## OROVILLE DAM AND RESERVOIR

### REPORT ON RESERVOIR REGULATION FOR FLOOD CONTROL

## G.6 Simulation of FIRO Alternatives

## Oroville's FIRO Space requirement

## 1997 120% Scaling Oroville

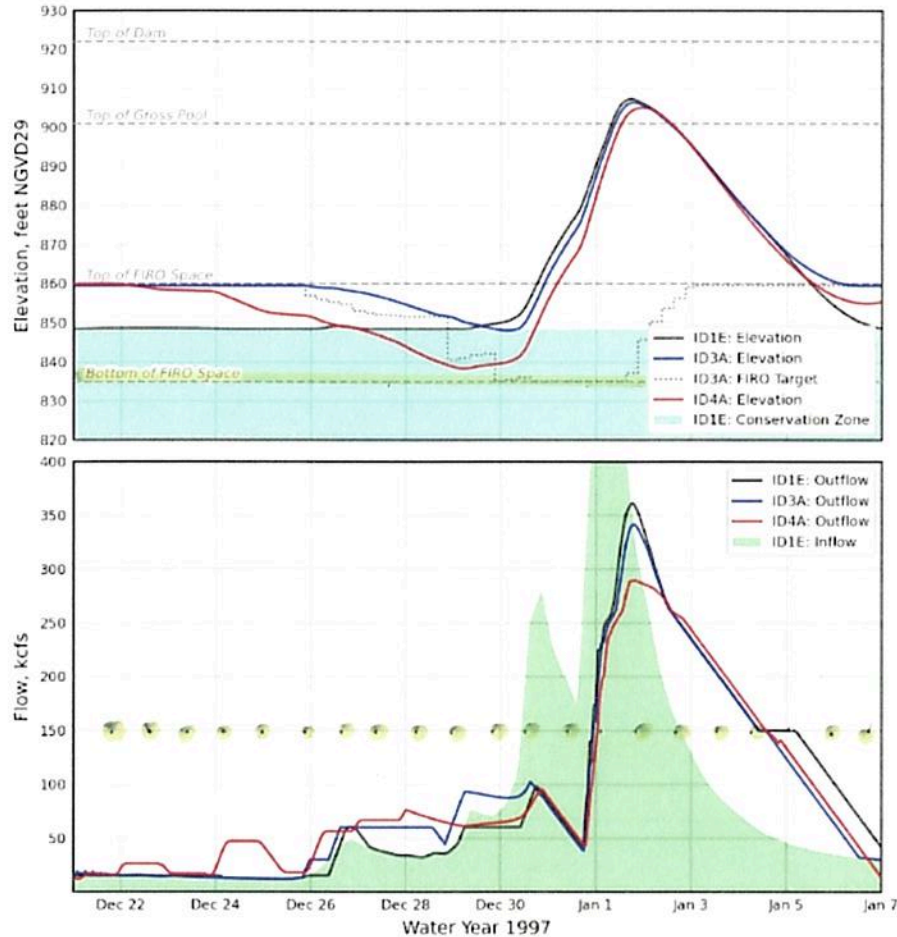
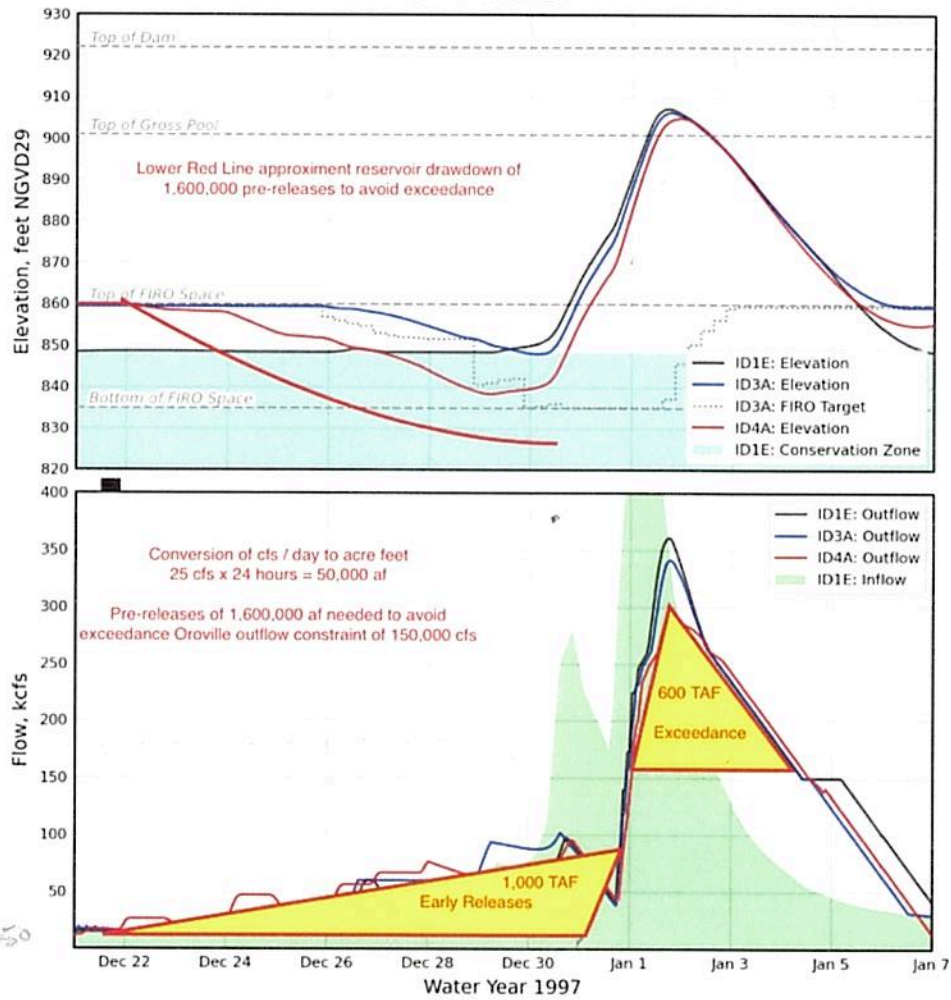
### SPF equivalent 440K cfs peak inflows

- Surcharges Auxiliary Spillway by 5-7 ft.
- The 2017 event surcharged 20 inches
- Outflows 300-350K cfs
- Targeted outflow limit of 150K cfs

## 1997 130% Scaling Oroville

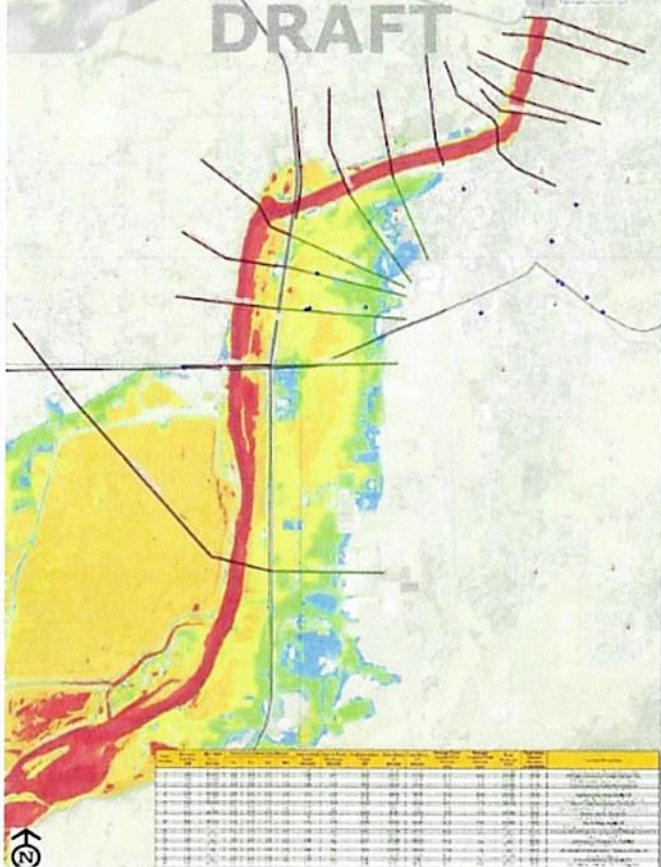
- City of Oroville Inundation Map**
- Standard Project Flood equivalent 440K cfs inflows
  - 300K cfs outflows at Oroville

# 2024 Spillway Performance

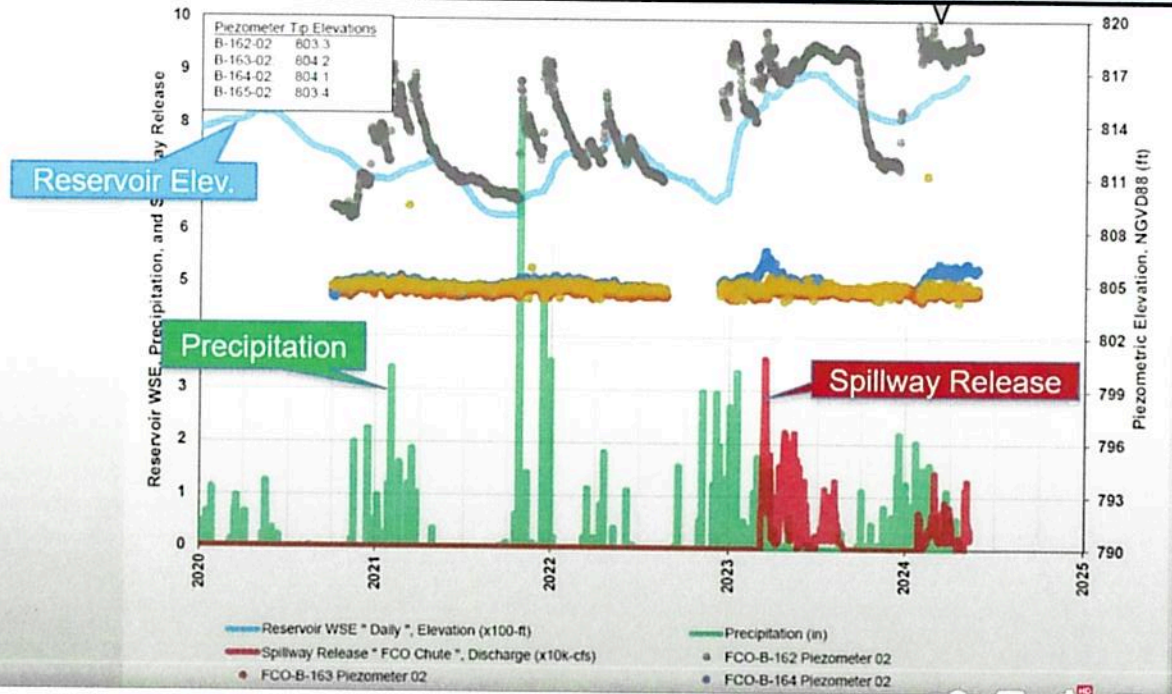
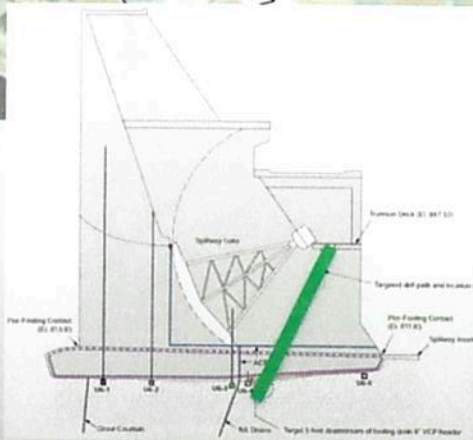
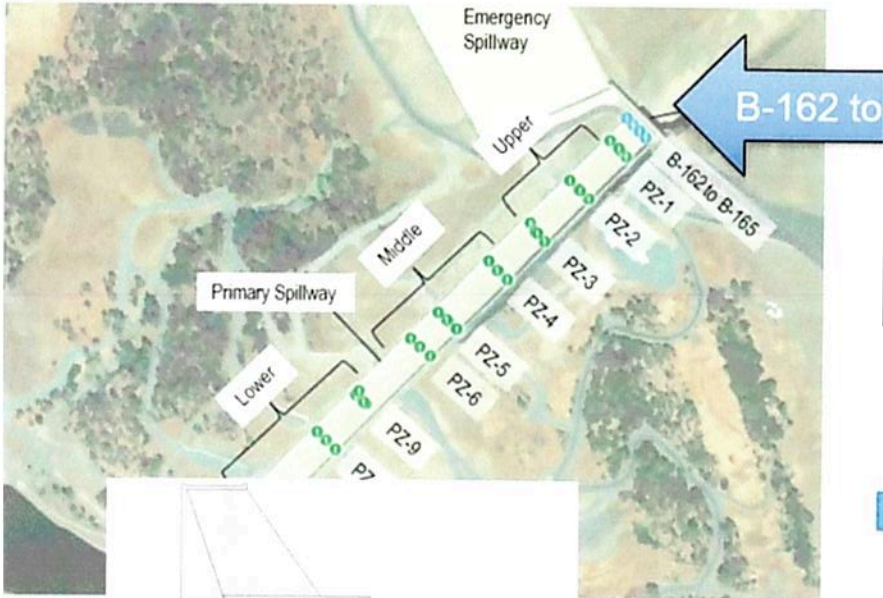
- Recovery of the conservation pool after a large event is not a concern.
- Are there infrastructure concerns when operating the FIRO space at elevation 813, bottom of the FCO-Gates?

Figure 3.3 Sacramento River Basin Index Points and Impact Areas

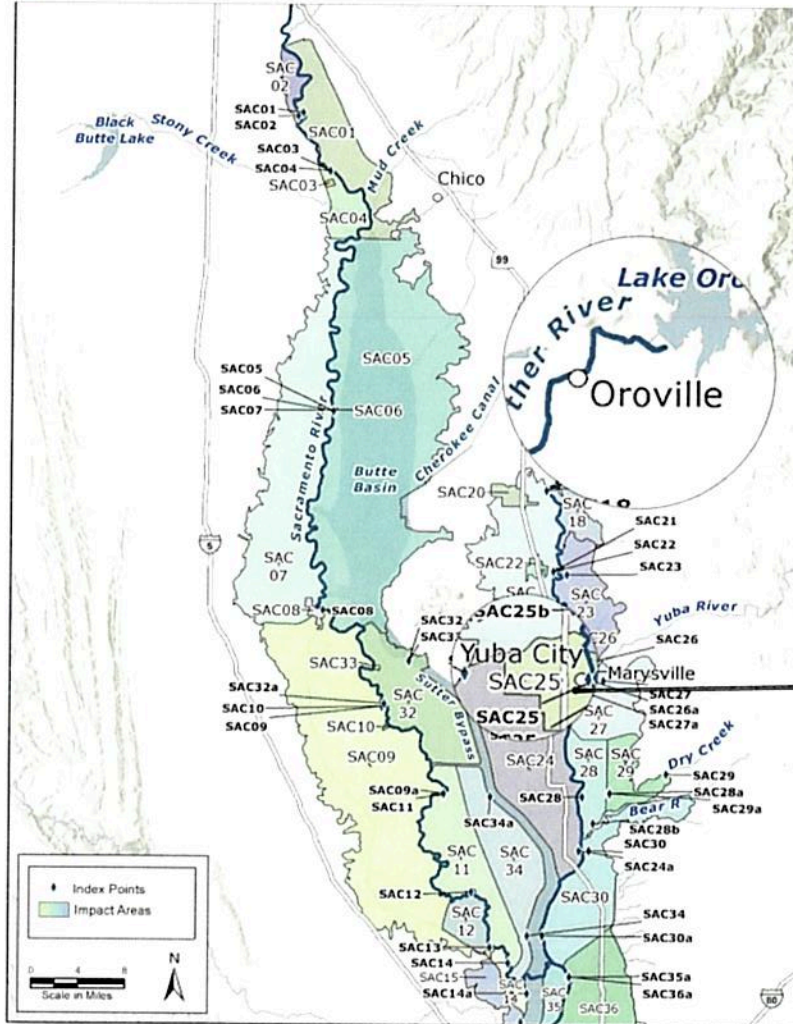
Yuba City Index SAC 25  
Check climate ratios in  
Appendix D

Figure 3-3. FIRO Space for ORO Reservoir.

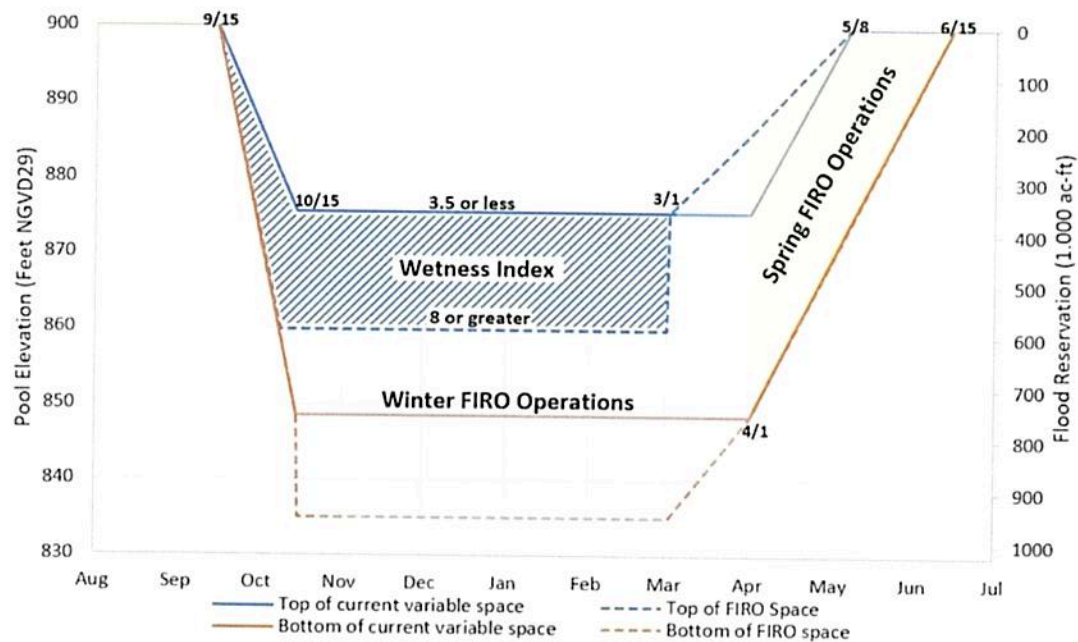
- FIRO Space 600-950K af
- Addition of Wetness Index can decrease Flood Pool to 350K af by assuming the watershed will absorb the first 250K af of precipitation
- Wetness Index does not account for the snowpacks water equivalency sitting on top of the soil

### Extreme Runoff Generation From Atmospheric River Driven Snowmelt During the 2017 Oroville Dam Spillways Incident

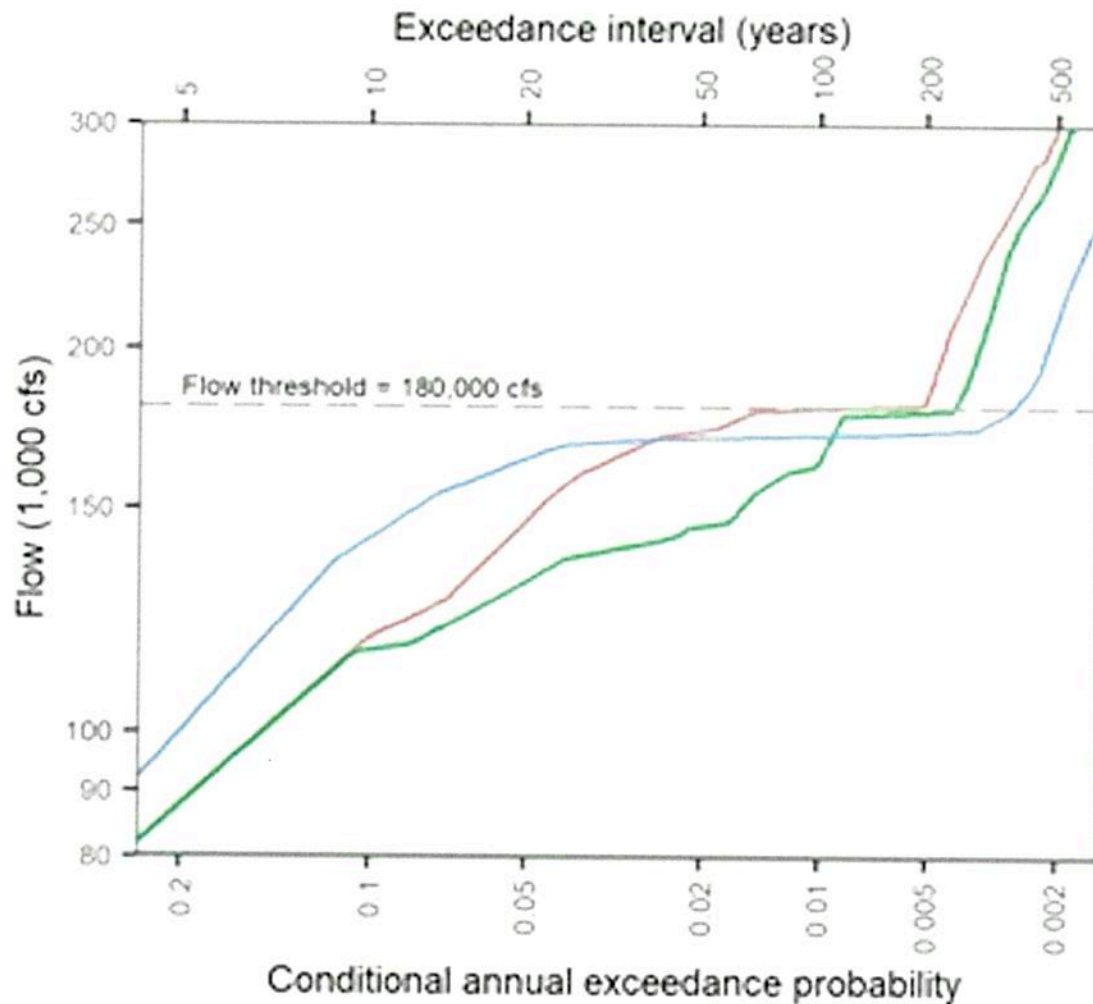
- An analysis of distributed snow water equivalency indicates that snow melt increased water available for run off - watershed wide by 37%
- Currently snow melt is not being considered in sizing of the variable FIRO flood pool
- Forecasted reservoir releases could be 37% higher on already reduced flood pool

Figure L-8. Frequency of end of flood season storage for ORO (top) and NBB (bottom) as a function of WCP alternative.

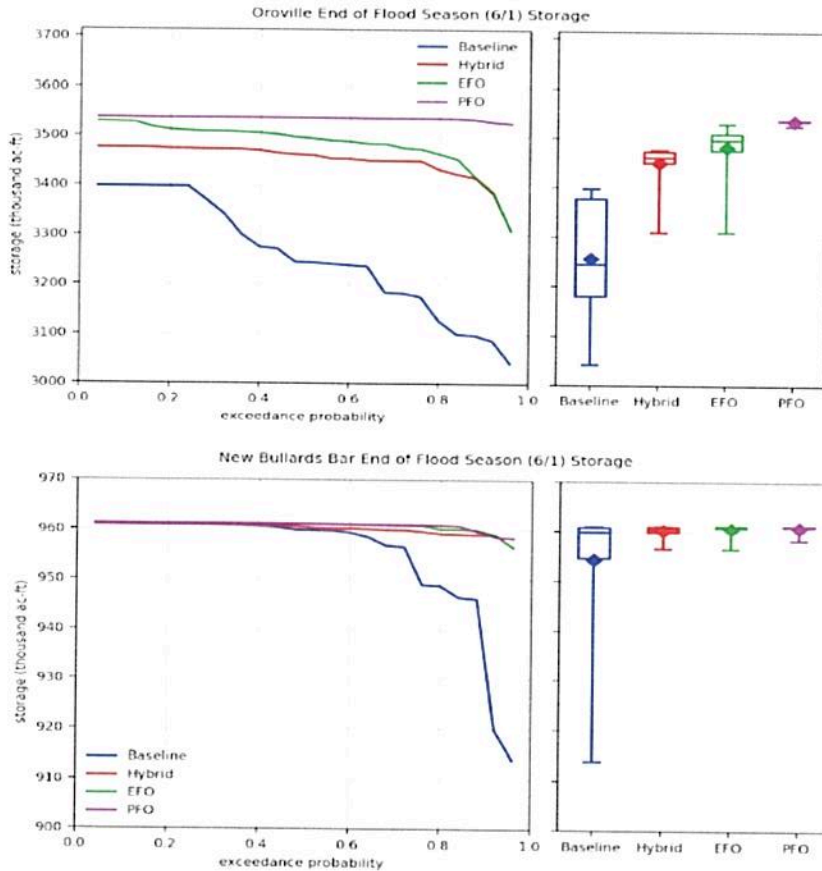
Estimated value of stored water \$1000/AF  
 200,000 AF x \$1000 = \$200M annual benefit  
 (Annual benefit over 5 years equals \$1 billion)
